Process Sheet

Drawing Name : REWORK

Job Number : 39299

DART SERVICE INSTRUCTION

FIGURE 1 - D350-636-011/-012/-013/-014 AT CHG 004 AND INSTALLATION OF DSI 9413-011
(LOCATION OF AN526C1032RXX SCREWS ARE NOT TO BE USED TO MOUNT WEARSHOES)

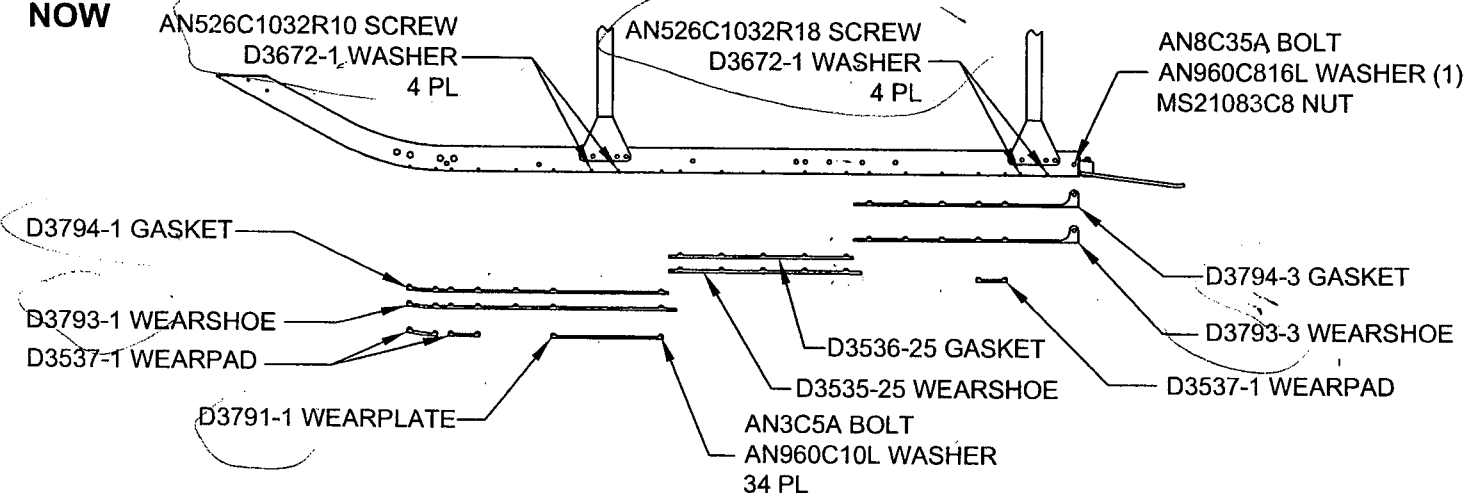
TO IMPROVE THE INSTALLATION OF THE DART D350-636-011/-012/-013/-014 SKIDTUBES ONTO THE CROSSTUBES, THE INSTALLATION AND PART NUMBERS OF THE FWD AND AFT WEARSHOES/GASKETS HAVE BEEN REVISED AS SHOWN IN FIGURE 1 BELOW.

WAS

NOW
